**Technical Service
BULLETIN**

**WATER LEAK AT HEADLINER
OR FLOOR AREA**

'05 – '07 Avalon, '07 Camry, & '04 – '07 Solara

REVISÉD
B0005-07
BODY

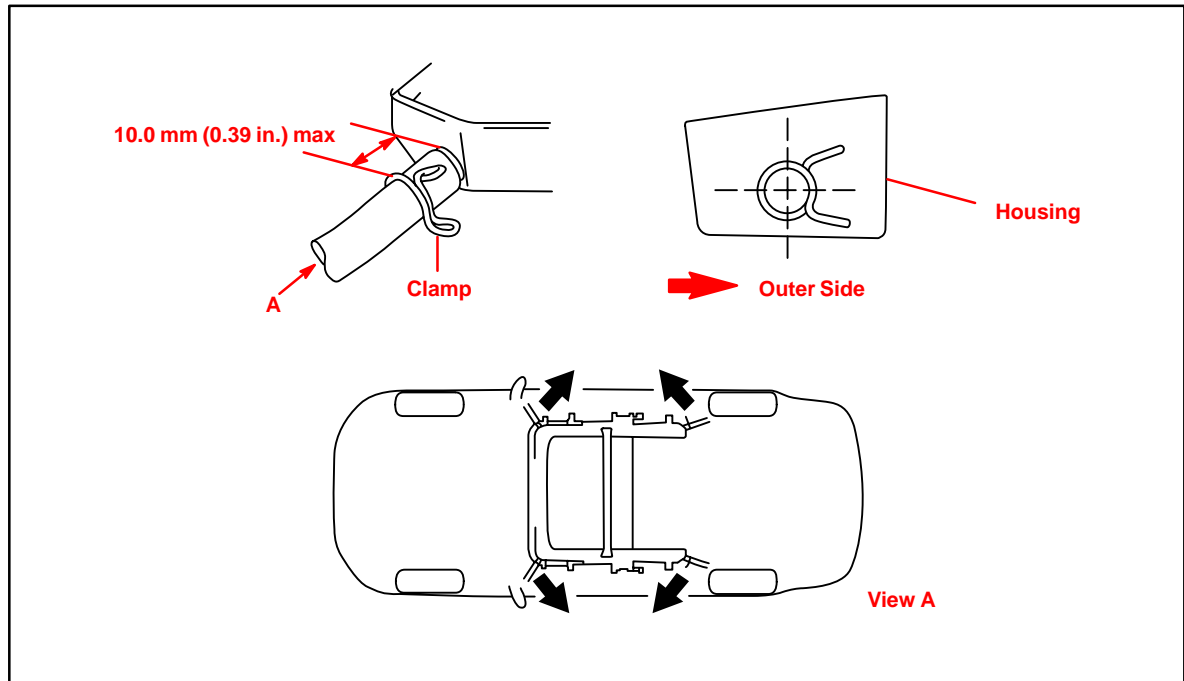
1. Remove the headliner.
2. Remove all 4 drain hoses from the drain pan nipples.
3. Install the drain hose clamps as shown in the diagram:

When installing the drain hoses, the 4 clamps **MUST** face toward the outside of the vehicle and also be above the lower surface of the sliding roof housing.
